MILLBURY PLANNING BOARD

Thursday, April 29, 2021

Reference: Public Hearing Comments (from a son of the owners and resident of **Map 62 Parcel 98**)
McLaughlin Family Living Trust (the "owners")
John Antaya (the "owners")
Kathleen (McLaughlin) Mardirosian (the "owners")
Whitney Street Home Builders, LLC (the "developer")
17 Rice Road, Millbury, MA (a/k/a Rice Pond Village Project)

Household Impact

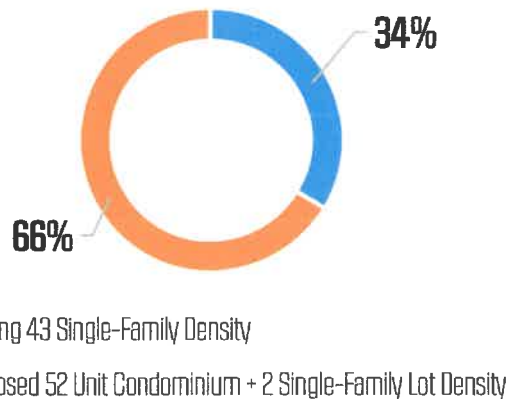
1. The scale of magnitude is far too great for a minor road (Rice Road) and would have a drastic and direct negative impact on the 43 existing single-family households³ (herein after referred to as the “neighborhood”) that have no other option available other than utilizing Rice Road for entry and egress. Fifty-two (52) additional dwelling units exceeds the current neighborhood on a significantly smaller footprint (lot). The Town of Millbury’s design standards, as posted on the town’s website (https://www.millbury-ma.org/sites/g/files/whlif4706/f/uploads/section6_0.pdf) includes specific roadway requirements that state that roads serving 21-149 dwelling units must be serviced by a 50-foot ROW and requires 26-foot width of pavement, Rice Road has a 40-foot ROW, no sidewalks, no bicycle lanes, and the condition of the pavement is poor at best (even prior to the recent natural gas and domestic water improvement projects). Rice Road does not meet the design standards as set forth by the Town of Millbury for the number of existing and/or proposed dwelling units. The magnitude proposed is greater than the entire existing neighborhood and what I can imagine in Boston or some other major inner cities, not a smaller community like Millbury. Higher density increases congestion and the odds of conflicts between people, residents and neighbors.

³ There is a total of 43 single-family houses on Rice Road, Aldrich Avenue, Thomas Hill Road and Captain Peter Simpson Road, excluding the McLaughlin Family Living Trust house at 17 Rice Road, that have **no other means of entry or egress than the use of Rice Road** to either Providence Road (Route 122A) or South Main Street. The original Brookvale Project encompassed 14, 17, 19 and 20 Rice Road and all lots on Thomas Hill Road, Aldrich Avenue and Captain Peter Simpson Road.

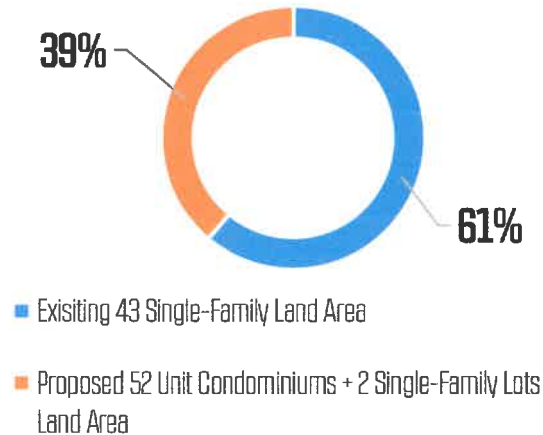
- AK Associates' Traffic Impact Study completely neglected to even consider the railroad crossing as risk factor. The pinch point (one vehicle at a time) in the road at the existing railroad crossing has been and is dangerous now, due to the configuration (narrow pavement width and approach angles), downgrade or upgrade depending on the direction of travel, unprotected Providence Road side (no guardrails), sightlines, etc. Adding 52 more units of vehicles (adding a minimum of 104 vehicles) to this railroad crossing will add a significant risk and problem that will need to be addressed in assessing their proposed plan and upgrades should be required prior to any demolition and construction commencing. The Town of Millbury should conduct a peer review to validate AK Associates' traffic engineer's conclusions independently. Mr. & Mrs. Donald Orrell, 1 Aldrich Avenue, recently recounted to me that they see people "flying over the railroad tracks" in the middle of Rice Road with no visibility if anyone is coming up from Providence Road (Route 122A) and are quite surprised that there has not been a serious accident or fatality to their knowledge. Other neighbors have conveyed similar "near-misses" of head-on incidents due to the almost non-existent sightlines at this railroad crossing due to the approach grades and angles, as shown in the embedded photographs. I, myself, have had these experiences, that have gotten worse over time, rather than better.

Rice Road beyond Aldrich Avenue in the direction of Providence Road (Route 122A) approaching railroad crossing. There is no visibility of any approaching vehicles. This photograph was taken at a 6± foot height, higher than the typical seated height in a motor vehicle, therefore, visibility is greater in this photograph than would be in a passenger vehicle.

Rice Road from Providence Road (Route 122A) in the direction of Aldrich Avenue approaching railroad crossing. There is no visibility of any approaching vehicles. This photograph was taken at a 6+ foot height, higher than the typical seated height in a motor vehicle, therefore, visibility is greater in this photograph than would be in a passenger vehicle.
